| Project: Town of Pendelton Community Center | Contract Name: Electrical Contract |

Attachments: CIR-COR #11 - Exterior Distribution Equipment Relocation

CHANGE ORDER REQUEST RECAP

Change Order Request No.: 11

| Material Description | Material | Labor Description | Hours | Rate | Labor Cost | |

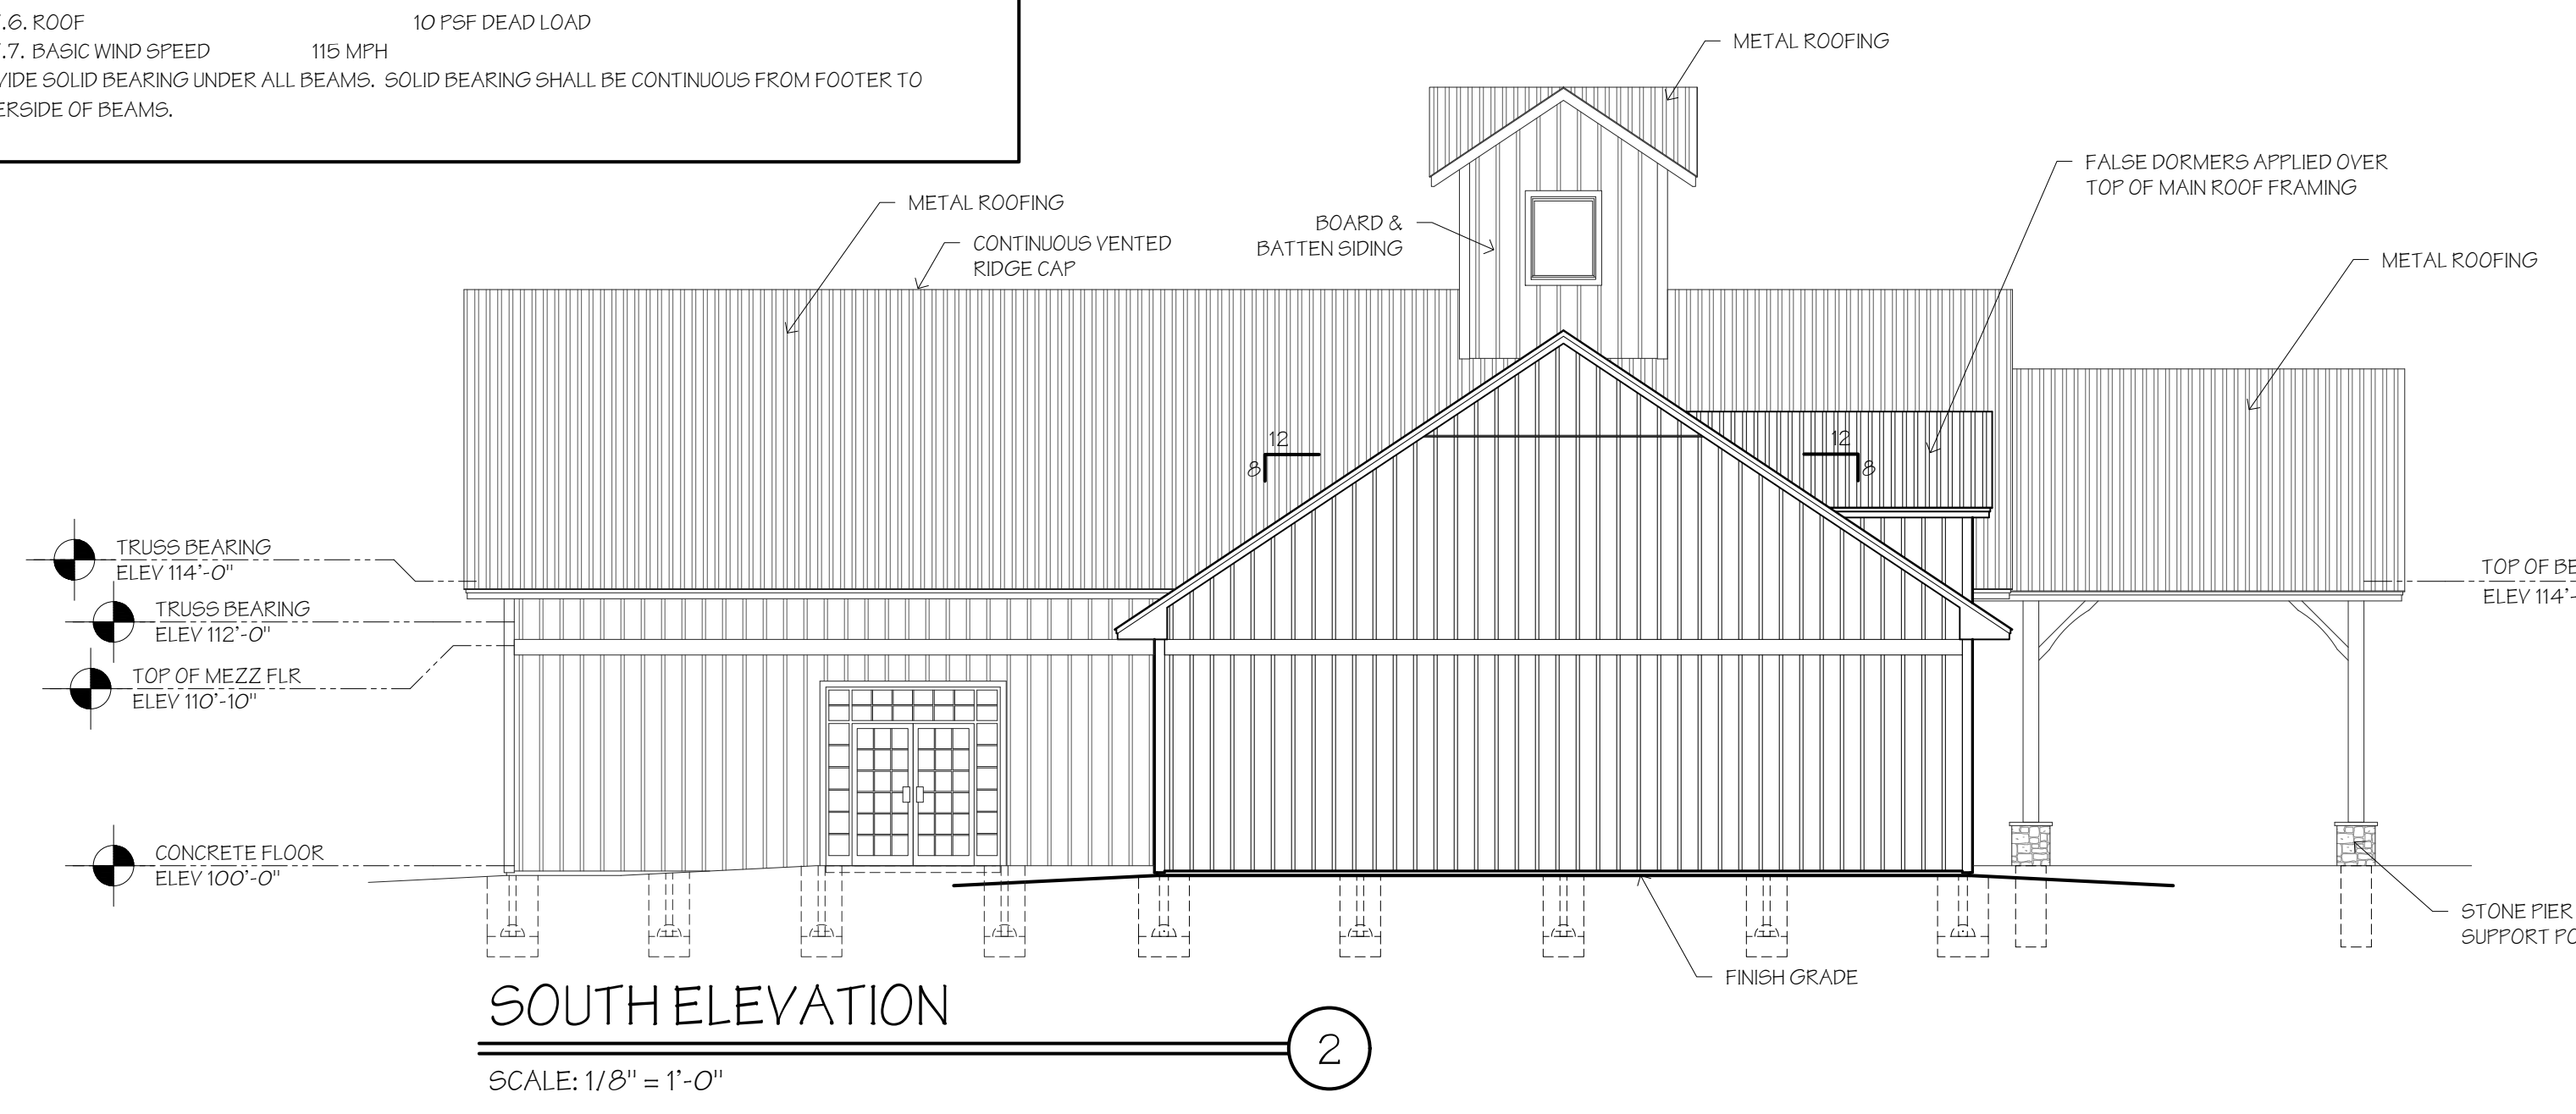
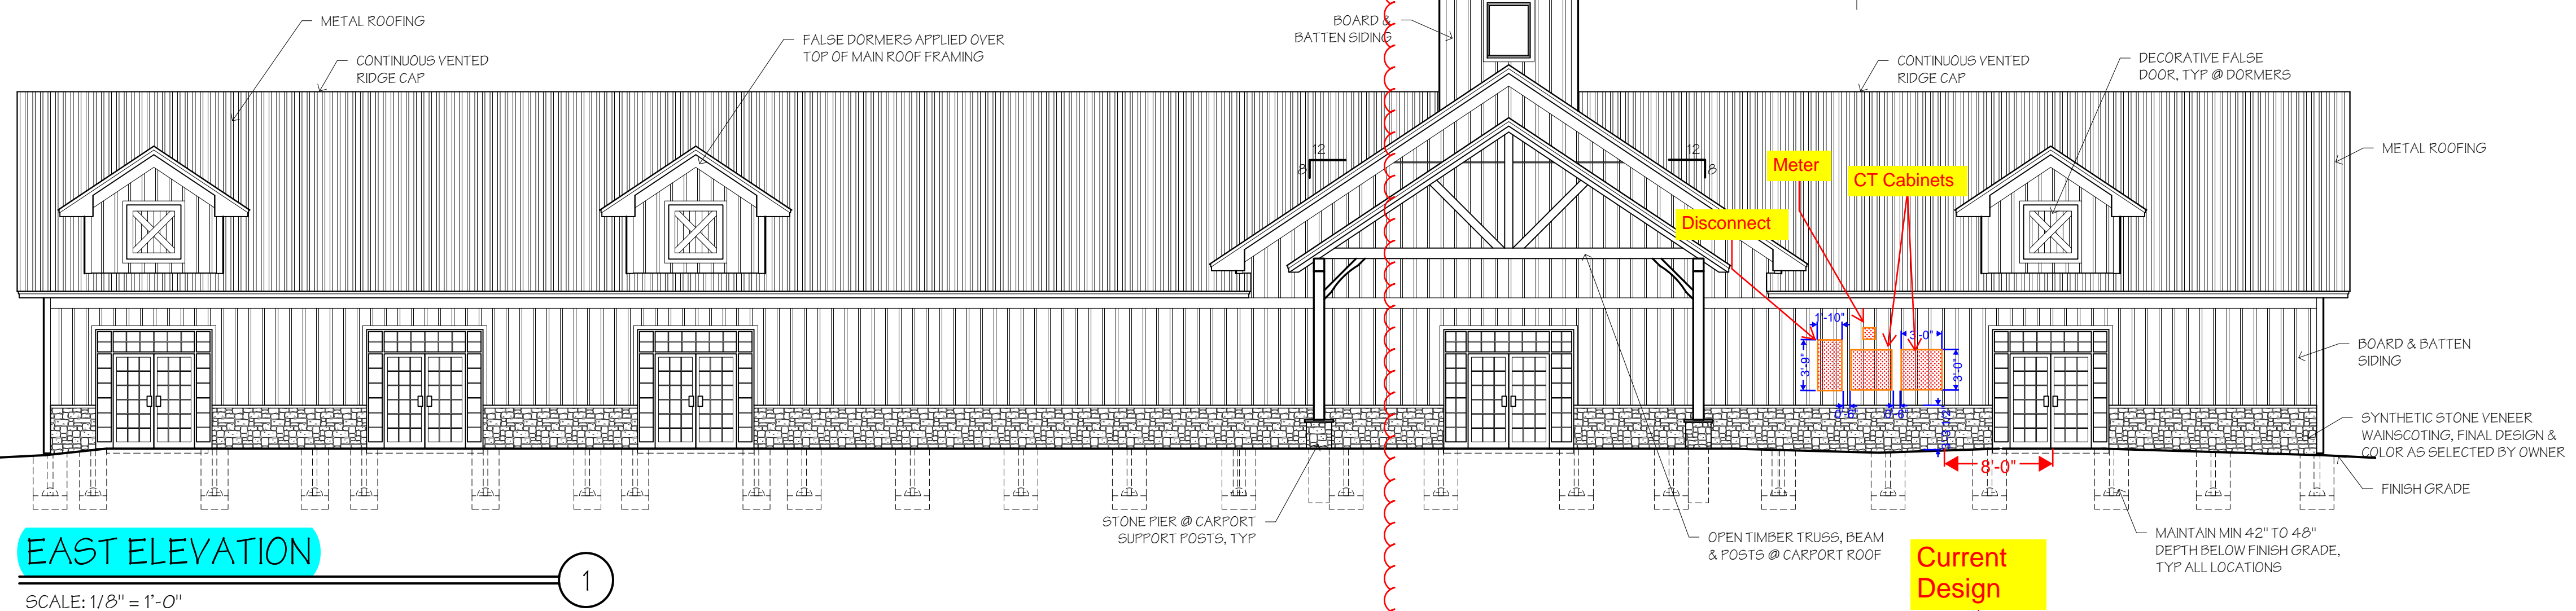
CIR to relocate existing exterior distribution equipment from east side of the community center (front), to the north side of the building. CIR to extend feed from exterior disconnect to MDP to accommodate relocation of equipment. Underground conduit length remains unchanged.
